The Rose of East Des Moines, LP - 1331 Idaho Street

ZON2006-00128

CONCEPTUAL PLAN FOR ROSE OF EAST DES MOINES, A PLANNED UNIT DEVELOPMENT IN THE CITY OF DES MOINES, POLK COUNTY, IOWA, SHEET 1 OF 4

ROSE OF EAST DES MOINES
PLANNED UNIT DEVELOPMENT
CONCEPTUAL PLAN

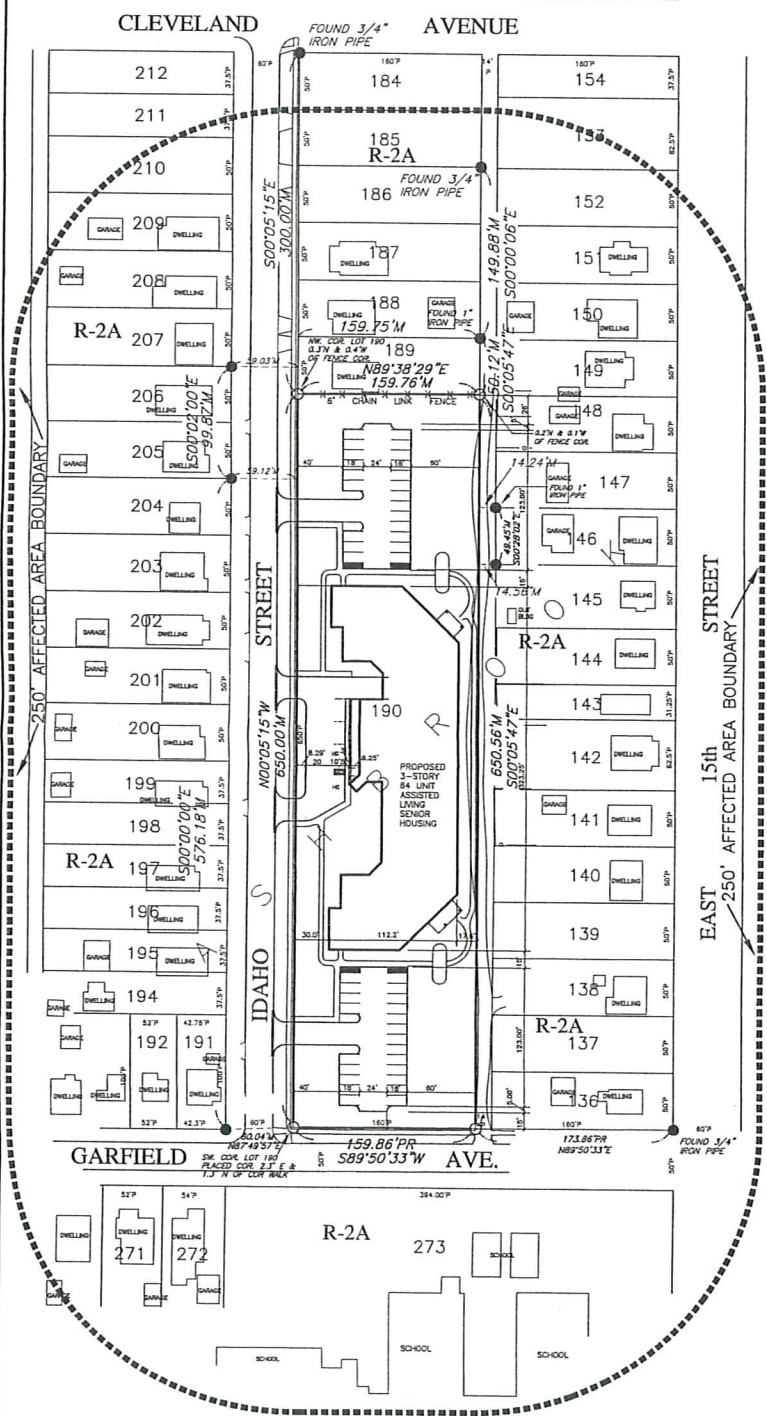
Part C) Staff recommends denial of the requested rezoning from "R-2A" General Residential District to "PUD" Planned Unit Development District on the basis that the proposed 64-unit, 3-story structure setback 12.6' from the east property line would be out of character with the low-density residential character of the neighborhood.

The building would be setback 35' from the west front property line adjoining Idaho Street and 158' from the south front property line adjoining Garfield Street. The building would be setback 12.6' from the east property line adjoining the north/south alley and 169' from the north property line adjoining a single-family dwelling. Staff believes that the proposed rear yard setback is inadequate as the *R-3 zoning district would require a 35' rear yard setback and the R-4 zoning district would require a 30' rear yard setback.*

Staff believes that the building mass of the proposed structure is not compatible with the existing architectural character of the surrounding area, as the proposed 3-

story structure would predominantly be surrounded on three sides by 1-story, single-family dwellings. The proposed building would be 323'-long with a 225'-long segment being within 12.6' from the east property line.

The proposed 3-story building with a maximum height of 40' is not proportional to the mass and scale of the surrounding single-family dwellings on the same block. The west facade is articulated, setback, and subdivided but the east facade is relatively flat and unbroken. The impact of this facade is intensified due to its placement 12.6' from the east property line. The R-3 zoning district would require a 35' rear yard setback and the R-4 zoning district would require a 30' rear yard setback.

1. compliance with the revised concept plan and landscape plan showing a minimum of 17.5 foot rear yard setback;
2. use of hardi-plank siding where siding was indicated on the submitted elevations.
